STRUCTURES DESIGN BULLETIN 13-03

ROADWAY DESIGN BULLETIN 13-04

DATE: April 9, 2013

SUBJECT: Concrete Surface Finish Requirements

Figure 4.4-1 Example Surface Finish Depictions on Grade Separation Structures

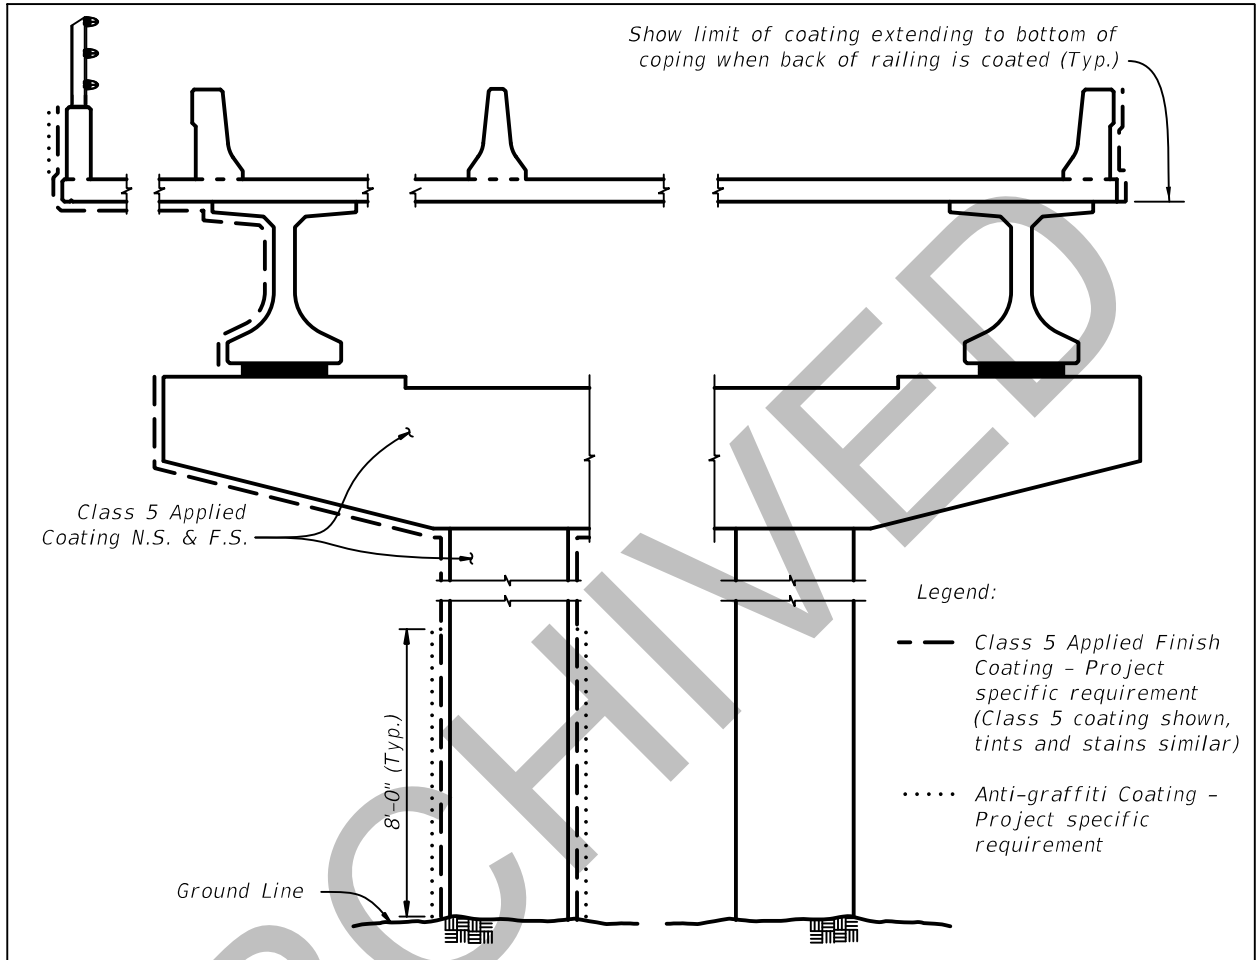
- A. If the use of coatings, tints or stains is necessary to meet project specific requirements in accordance with the limitations specified in *SDG* 1.4.5, show the limits of the areas to be treated in the plans. See examples of how to depict the limits of treatments in Figure 4.4-1, Figure 4.4-2, Figure 4.4-3 and Figure 4.4-4. For bridges and retaining walls with Class 5 coatings, show appropriate "Class 5 Applied Finish Coating" notes in the General Notes and the corresponding Surface Finish Details on the General Notes drawing. For noise walls, see the *Instructions for Design Standards* Index 5200. If the finish color is other than Federal Color Standard No. 595, Color No. 36622 (standard concrete gray) (or Color No. 36642 for uncoated weathering steel bridges), specify the appropriate number(s) for the desired color(s). Do not use generic or brand names for colors, e.g. Pearl Grey. Provide similar notes and details for the use of tints and stains.

- B. If the use of an anti-graffiti coating is necessary to meet project specific requirements, show the limits of the areas to be coated in the plans. See examples of how to depict the limits of anti-graffiti coatings and recommended areas to be coated in Figure 4.4-1, Figure 4.4-2, Figure 4.4-3 and Figure 4.4-4. Specify the type of anti-graffiti coating to be used in the plans, e.g. sacrificial or non-sacrificial.
